ADDENDUM NO. 1

POLYTECH HIGH SCHOOL
RENOVATIONS AND ADDITIONS
BID PACKAGE 'A'

This addendum is hereby made part of the Project Manual and Drawings dated 9 July 2012.

CSK031

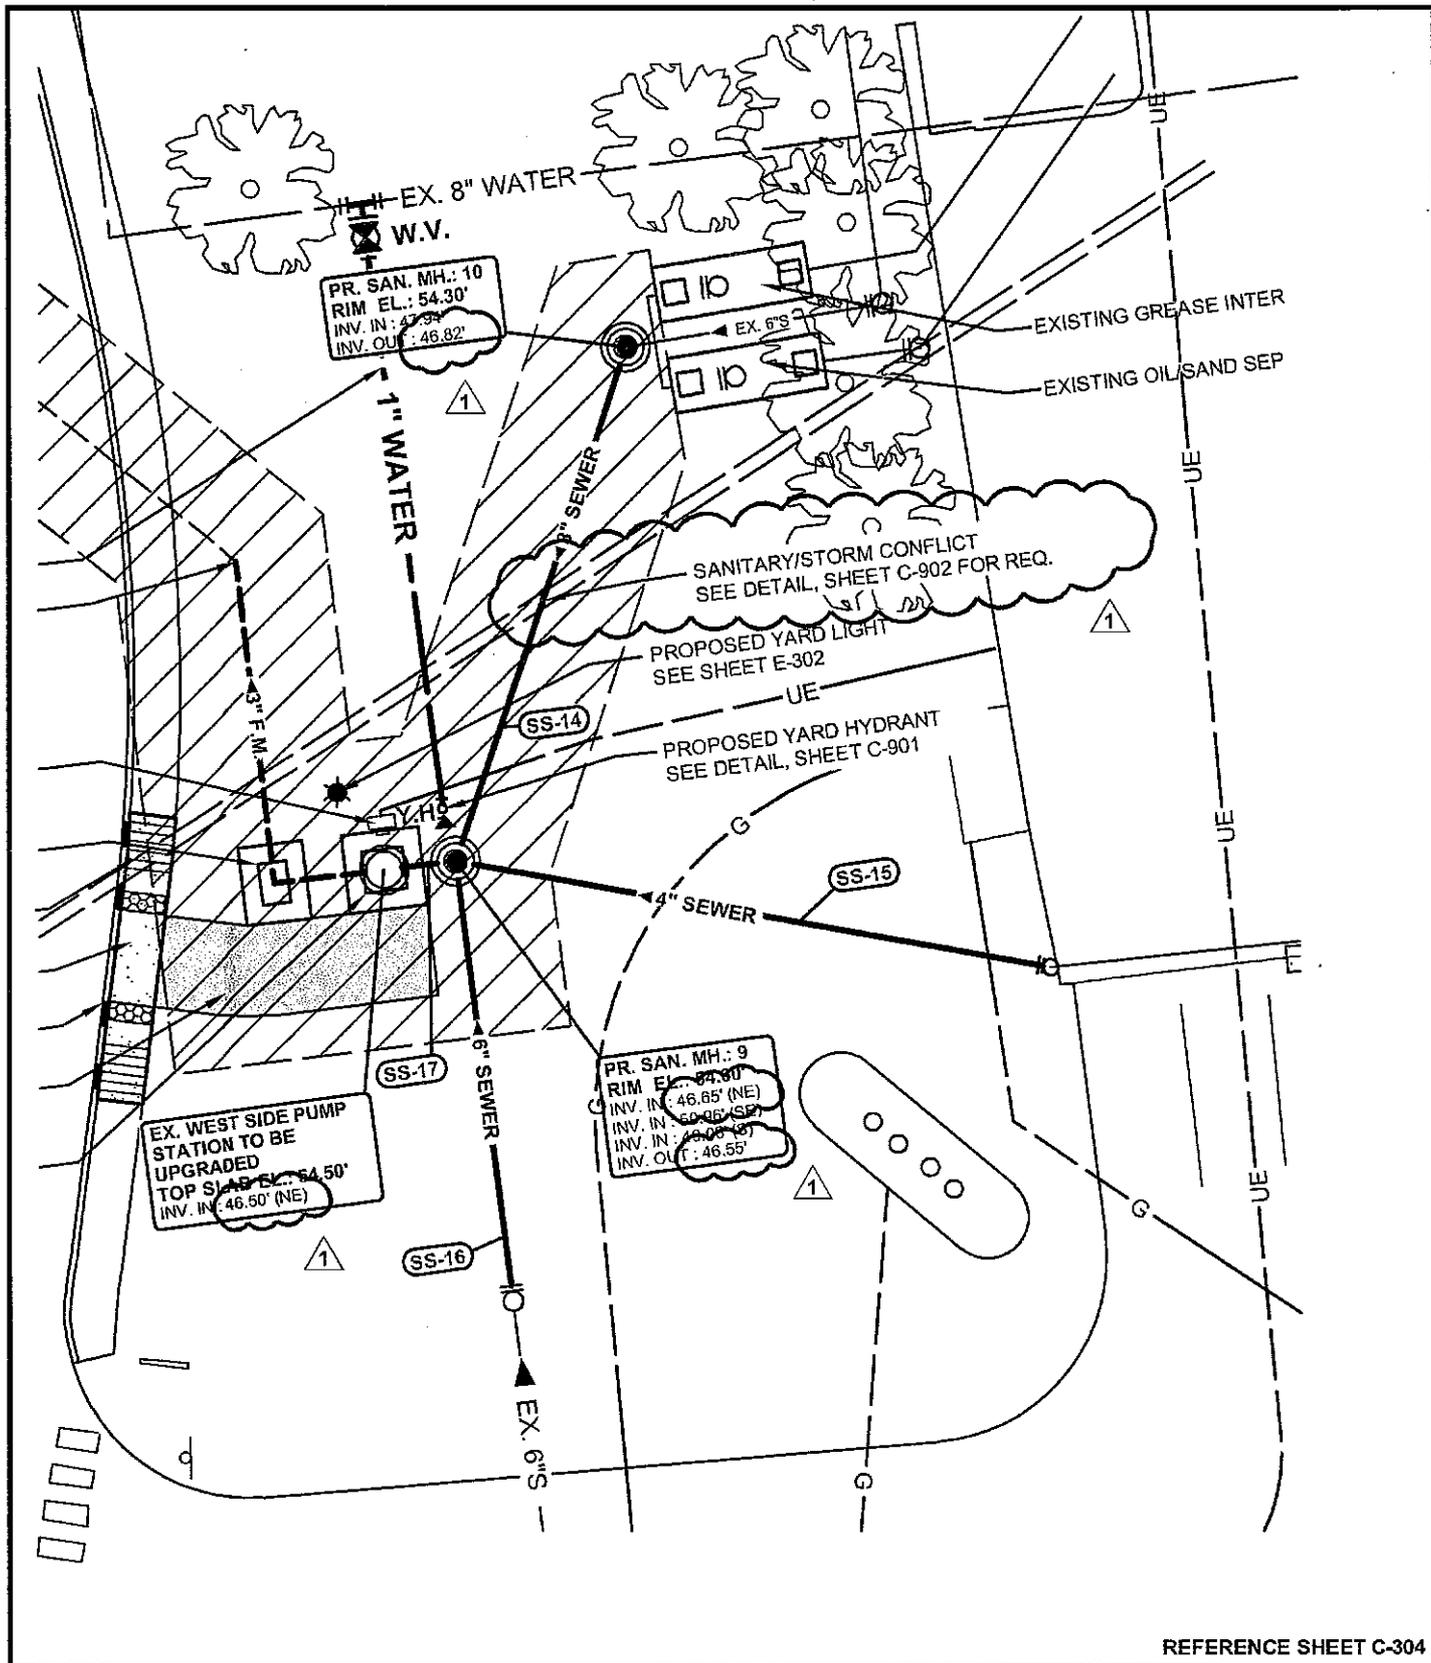
- H. **C-302 Utility Plan** - Drawing revised as indicated on sketches CSK010, CSK011, and CSK012 and included with this addendum.
- I. **C-303 West Side Pump Station Plans, Sections and Notes** - Drawing revised as indicated on sketch CSK031 and included with this addendum.

CSK034

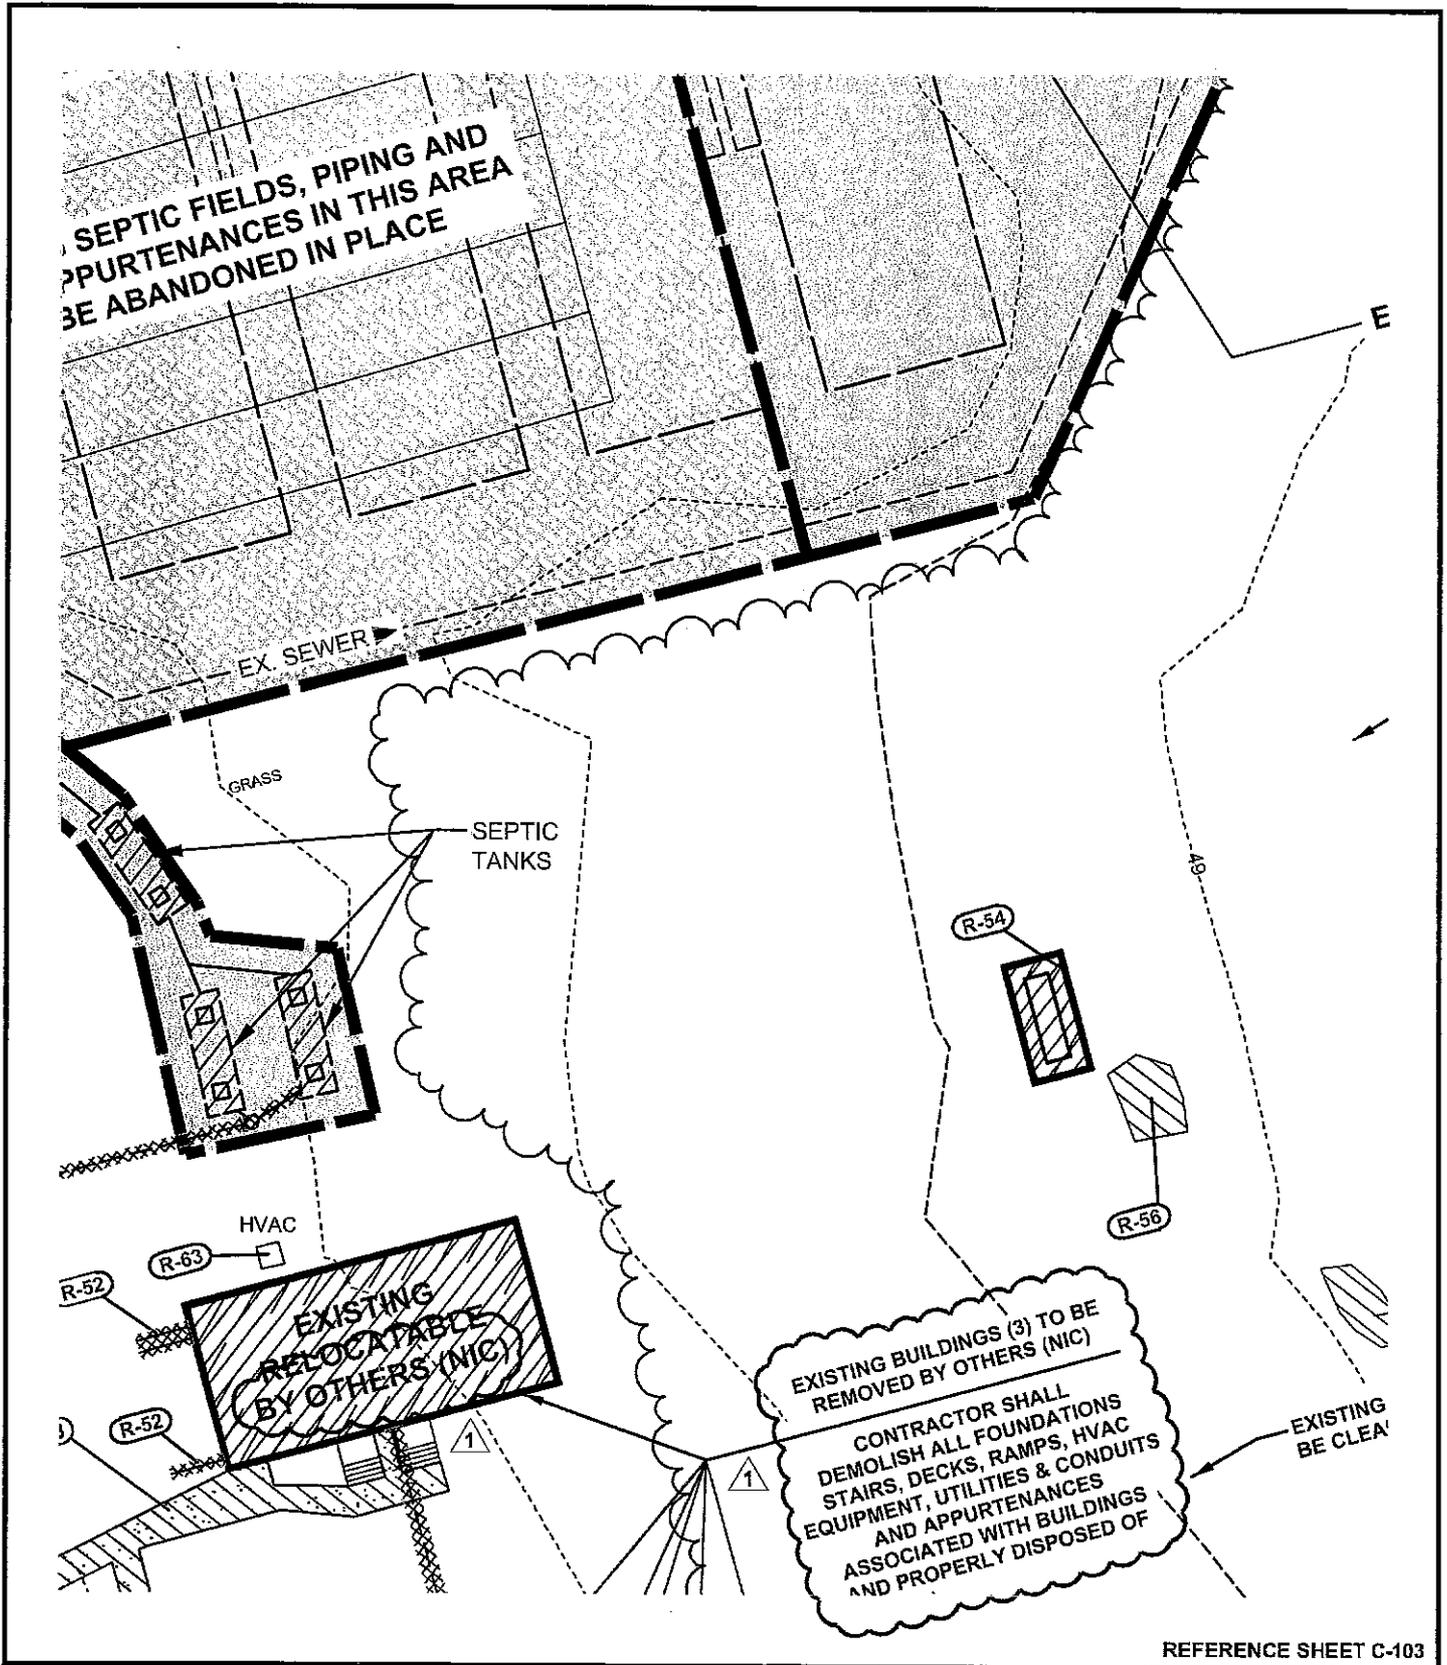
- B. **C-102 Demolition Plan** - Drawing revised as indicated on sketches CSK034 and TEMP-001 and included with this addendum.
- C. **C-103 Demolition Plan** - Drawing revised as indicated on sketches CSK035, TEMP-002, and TEMP-003 and included with this addendum.

Sketch TEMP-001
27 Jul 12

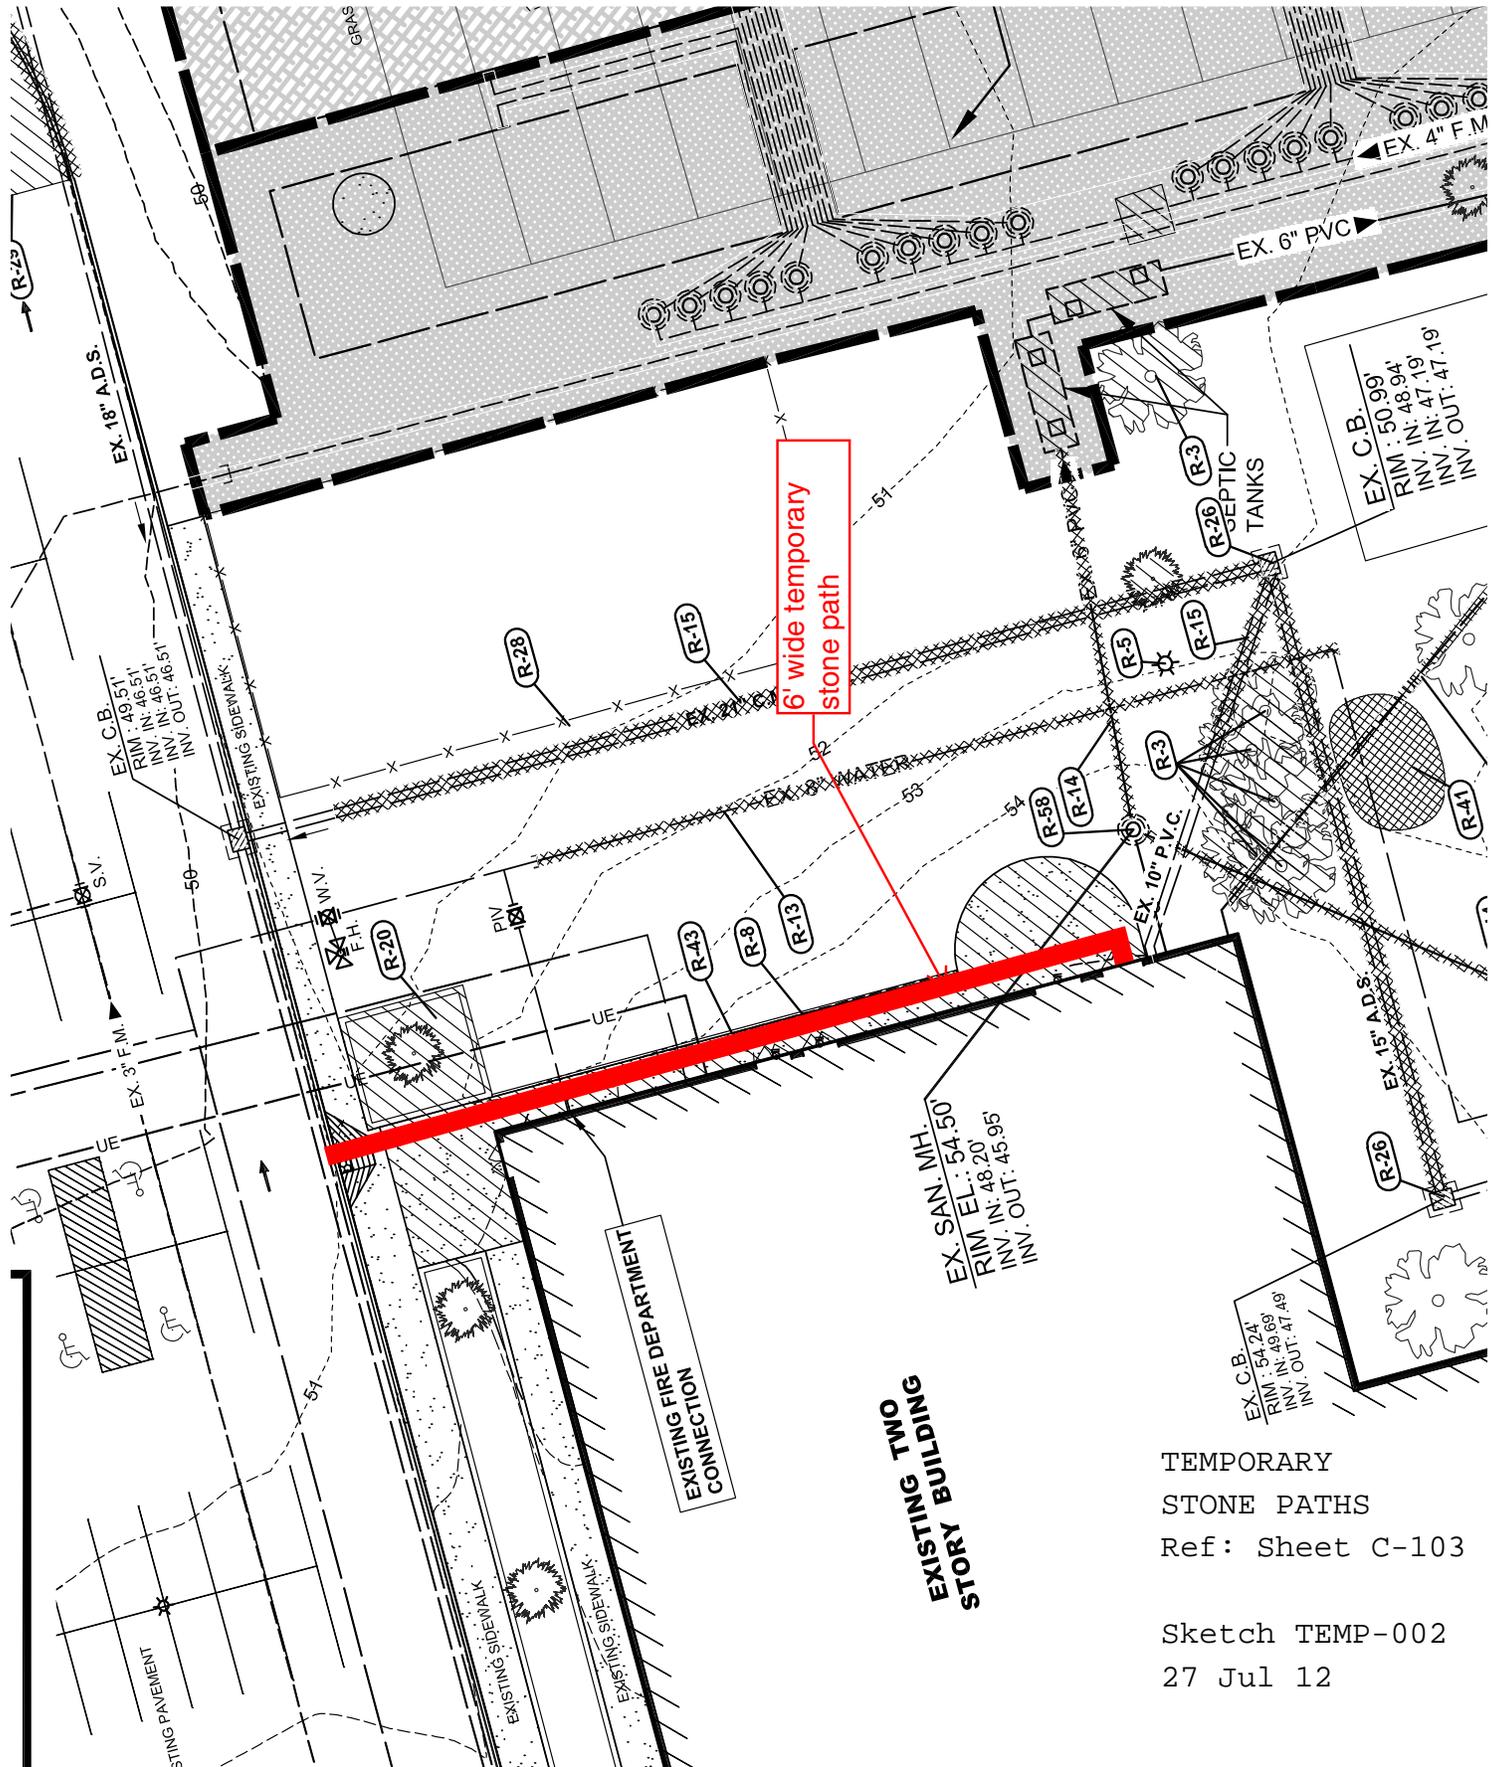
“Provide and maintain temporary stone dust paths from the emergency doors of the existing high school. The paths shall be 6’ wide and 6” deep. Provide and maintain a temporary access road between the existing west parking lot and the existing roller skating rink. The road is to be constructed of stabilized stone material, crushed concrete or asphalt millings. Road will be 24’ wide and 12” thick. Maintain paths and access road during the duration of construction. See sketches TEMP-001, TEMP-002, & TEMP-003.”
